# **BART SILICON VALLEY**

## **Phase 1 – Berryessa Extension**

### **Addendum No. 4 to the 2<sup>nd</sup> Supplemental Environmental Impact Report**

**Santa Clara Valley Transportation Authority**

Figure 3: Conceptual Drawing of Current Design of Systems Facilities Layout

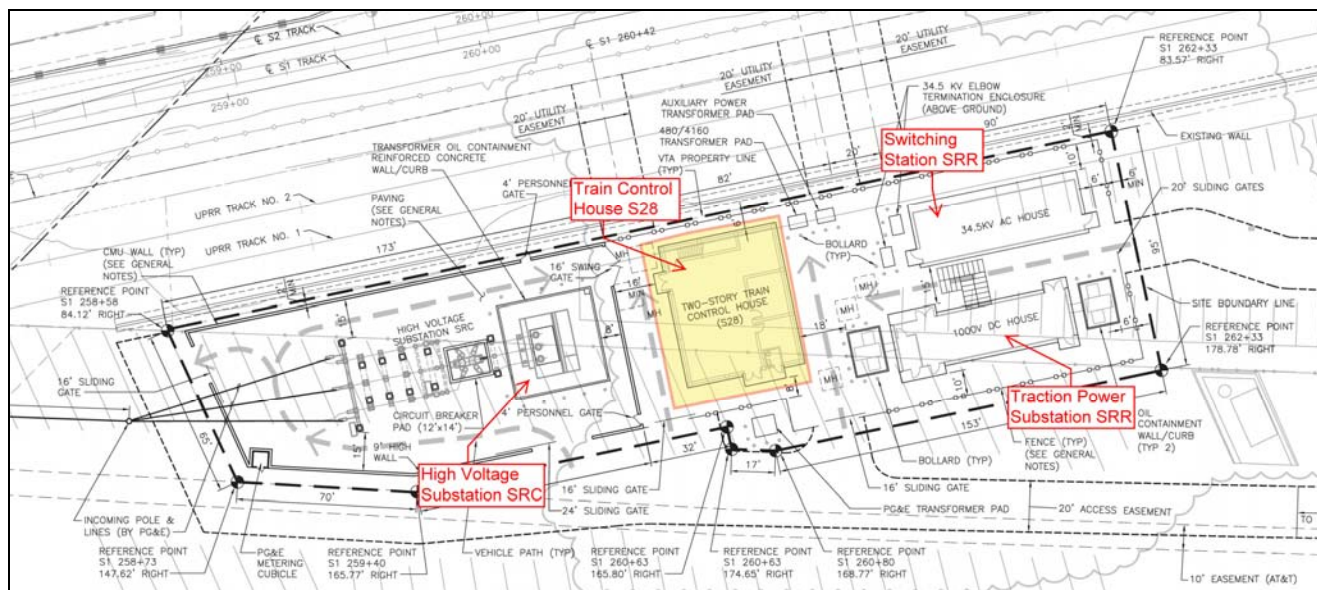
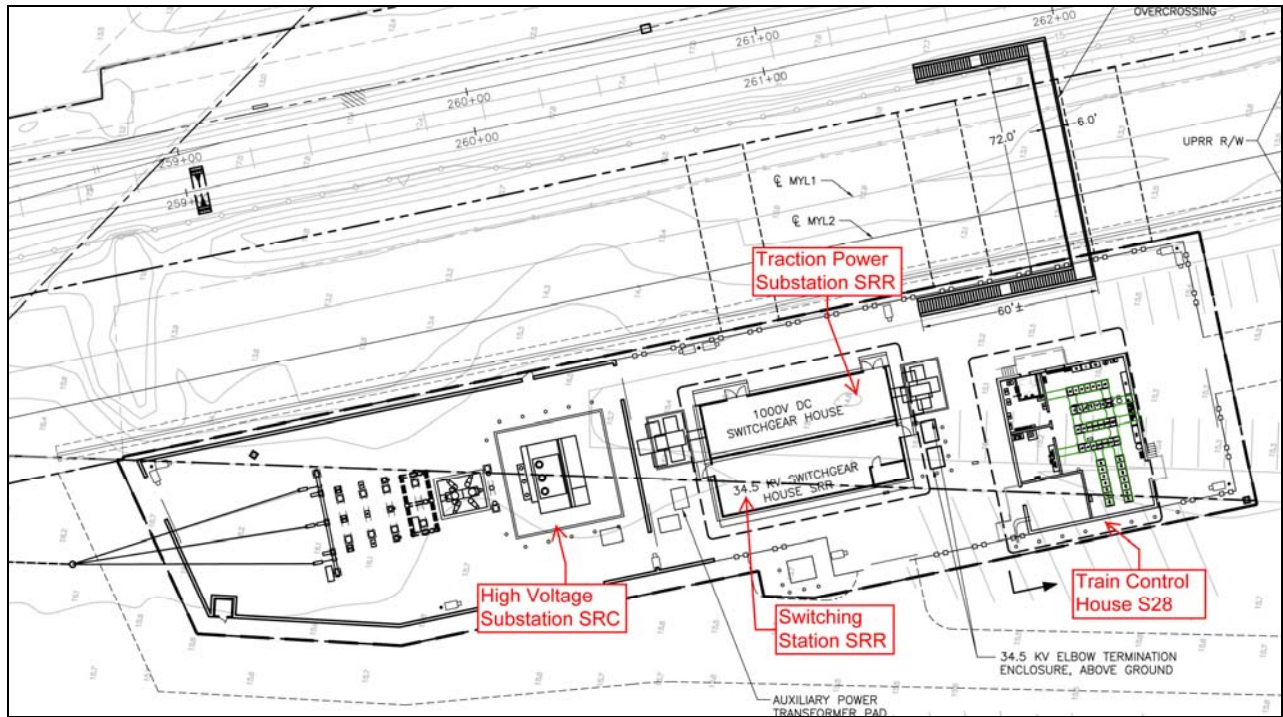
Since Addendum No. 3 was approved in May 2012, the layout of the buildings has changed slightly due to refinements in design, as shown below in Figure 3. The location of the High Voltage Substation SRC has not changed. However, Train Control House S28 was relocated to the south and has been reduced from a 2-story structure to a 1-story structure. Switching Station SRR and Traction Power Substation SRR have been moved to a location between the High Voltage Substation SRC and the Train Control House S28. Also, Switching Station SRR and Traction Power Substation SRR have been placed adjacent to one another to reduce the overall footprint within the site and to improve internal circulation of maintenance vehicles within the Systems Facility site. The proposed access to this facility has not changed since the previous Addendum No. 3 was approved by the VTA Board in May 2012. The access easements over the Walton and Horner properties were environmentally cleared in Addendum No. 3. There has been no change in the overall footprint of the Systems Facility and no new right-of-way would be necessary to accommodate the changes described in this Addendum.

Figure 5: Current Design for Location of PG&E Poles

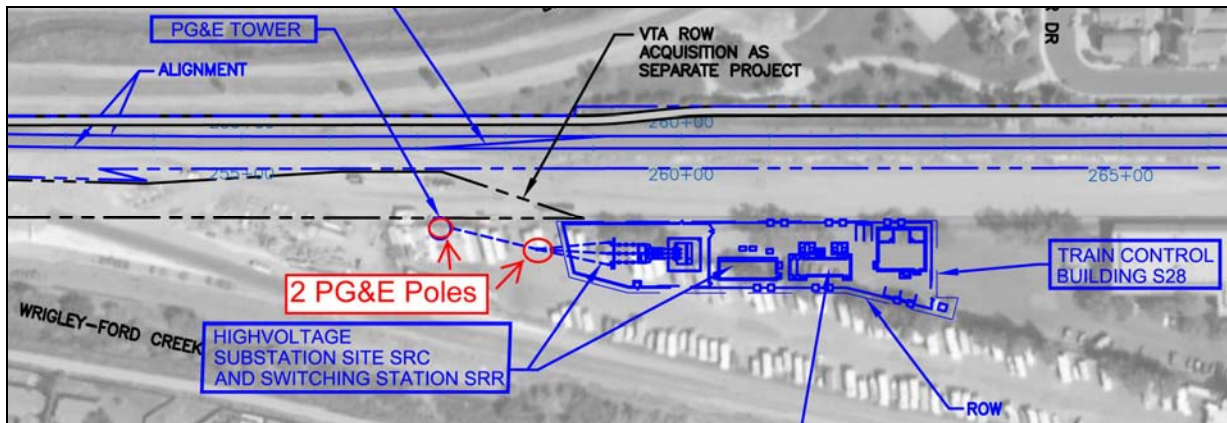
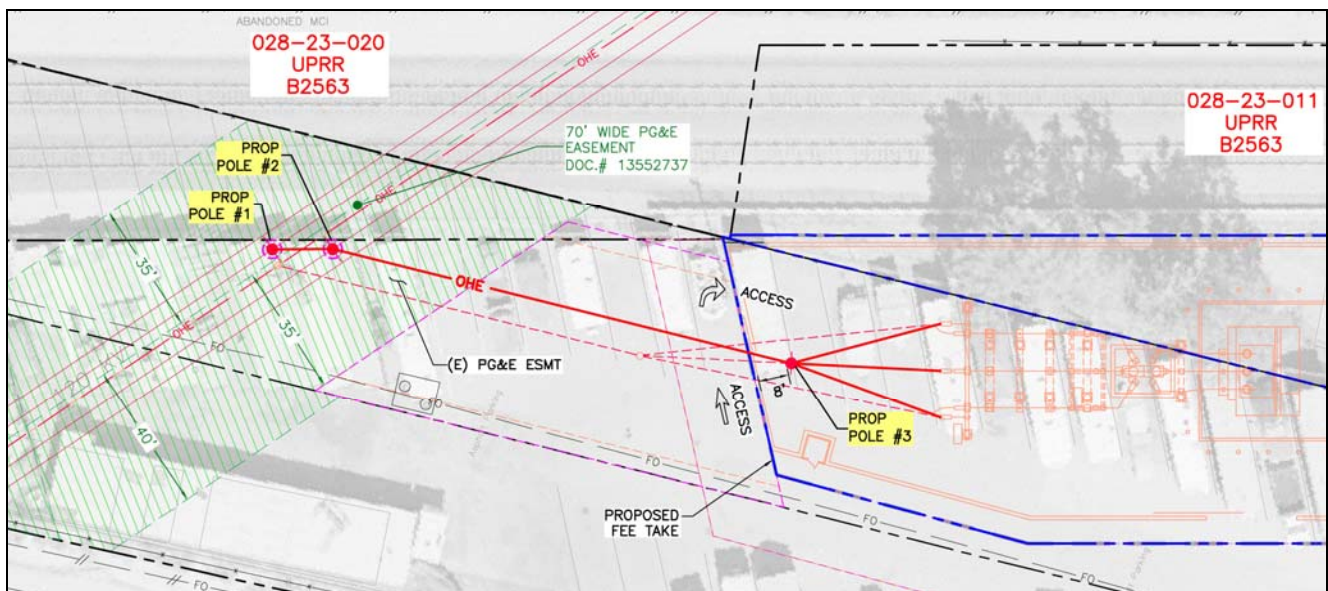
Since Addendum No. 2 to the 2<sup>nd</sup> SEIR was approved in May 2012, designs for the PG&E connection to the Systems Facility at Railroad Court have been further refined. There are two changes to the proposed PG&E poles located at this site. The first change is the addition of one new PG&E pole at the northern end of the Horner property within PG&E's easement. According to PG&E's design standards, two 80 to 110 foot high tubular steel PG&E poles are necessary to help stabilize the 115-kV lines at the connection to the High Voltage Substation. Addendum No. 2 described only one new pole to stabilize the new connection at this location. PG&E is now requesting two new poles for stabilization. This is a net change in one additional pole necessary at this location. The second change relocates the southernmost PG&E pole farther to the south. Previously this pole was located outside of the System Facility. However, with the shift to the south, this PG&E pole would be located inside the footprint of the System Facility. As shown in Figure 5 below, the current design shows a total of three PG&E poles in comparison to the two poles shown in Figure 4 above.

Figure 6: Alternate Route Map for Access Between Track Switches and System Facilities

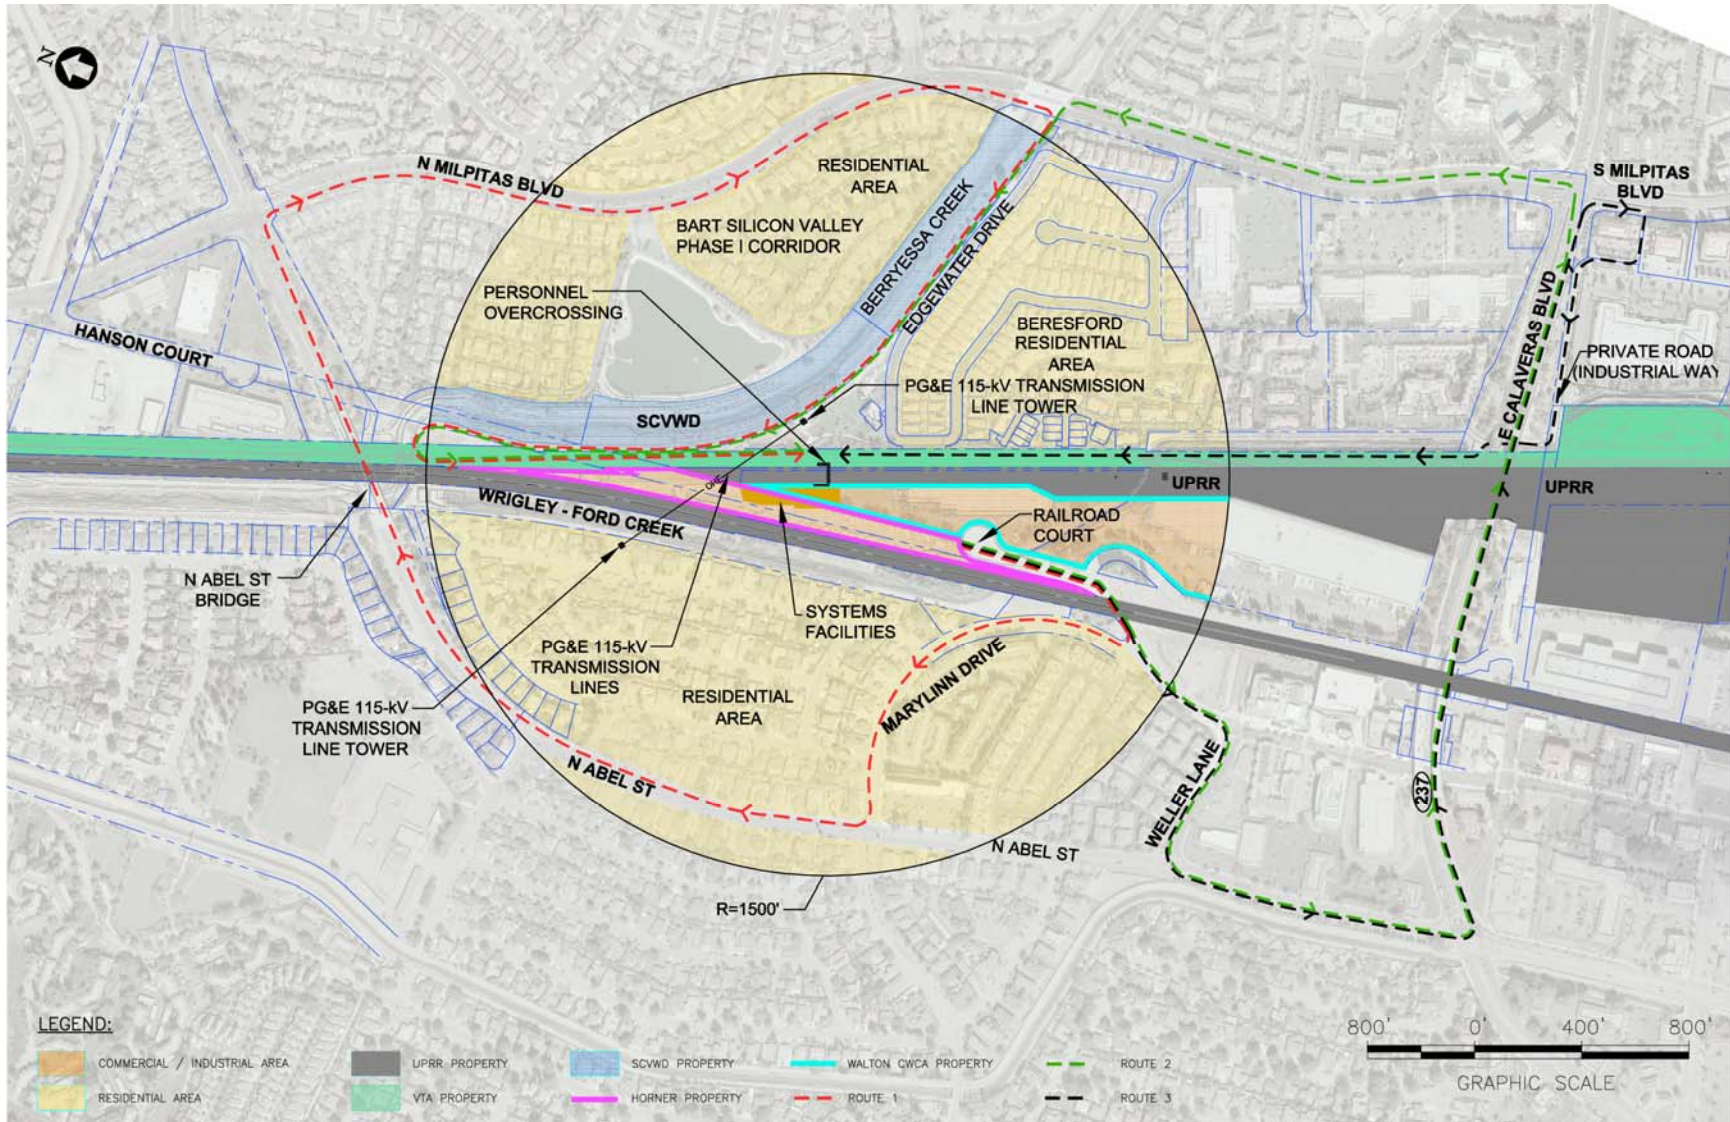
The three routes described above would add an additional travel distance of approximately 2 miles and take approximately 20 minutes of travel time *in each direction*, which would compromise the ability of maintenance personnel to complete their scheduled tasks within the limited maintenance window during non-operating hours.

**Figure 7: Conceptual Drawing of Proposed Overcrossing and Train Control Building, Looking South**

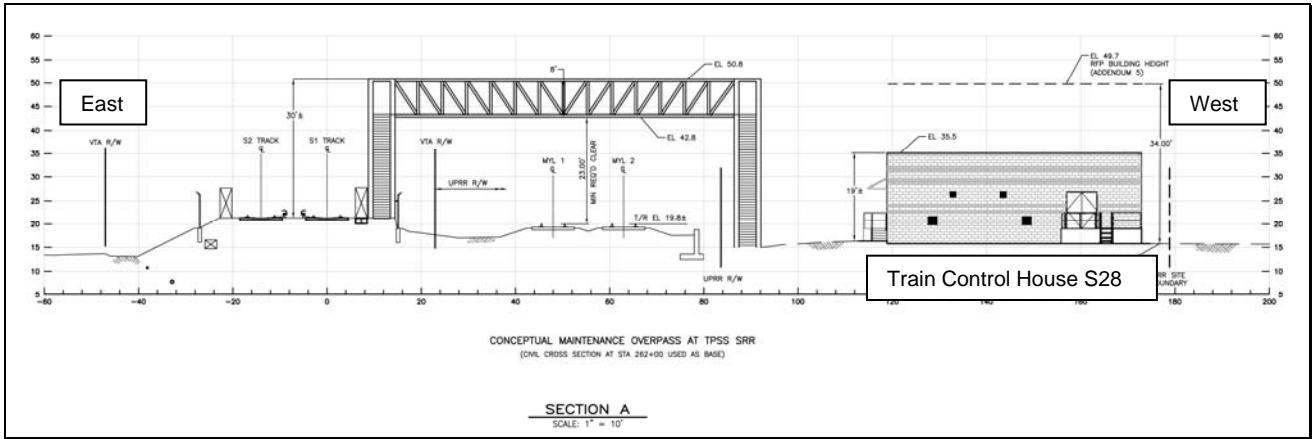
Therefore, VTA has designed a new freestanding pedestrian bridge that would span the UPRR tracks from the BART Alignment to the Systems Facilities at approximately Station 262+00. Final design has not been completed, but the crossing would be approximately 70 feet long and have a minimum clearance of 23 feet from the top of the UPRR tracks to the lowest part of the underside of the bridge. The top of the overcrossing would be approximately 31 feet above the top of the UPRR tracks. See Figure 7 below for the section drawing of the conceptual design of the freestanding overcrossing and stairs in relation to Train Control House S28.

**Figure 8: Conceptual Drawing of Proposed Systems Facility and Overcrossing, Looking East**

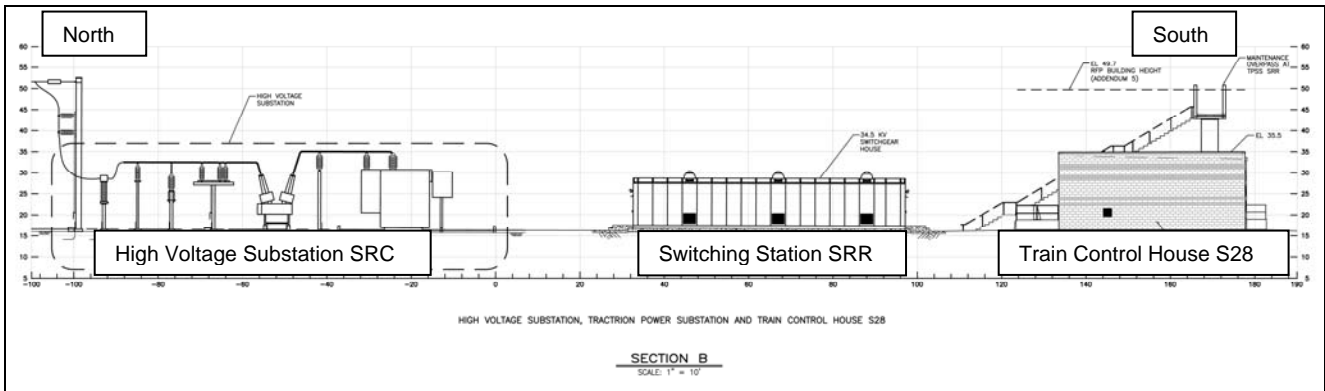
The overcrossing would include stairs on both ends, both of which would land in secured areas. The eastern set of stairs would land within the BART Alignment, just west of the BART tracks. The western set of stairs would land within the footprint of the Systems Facilities. The western stairs would land within the previously environmentally cleared footprint of the Systems Facilities and no new right-of-way would be required from the Walton property. See Figure 8 below for a section view of the layout of the Systems Facility. The overcrossing can be seen directly behind the Train Control Building.
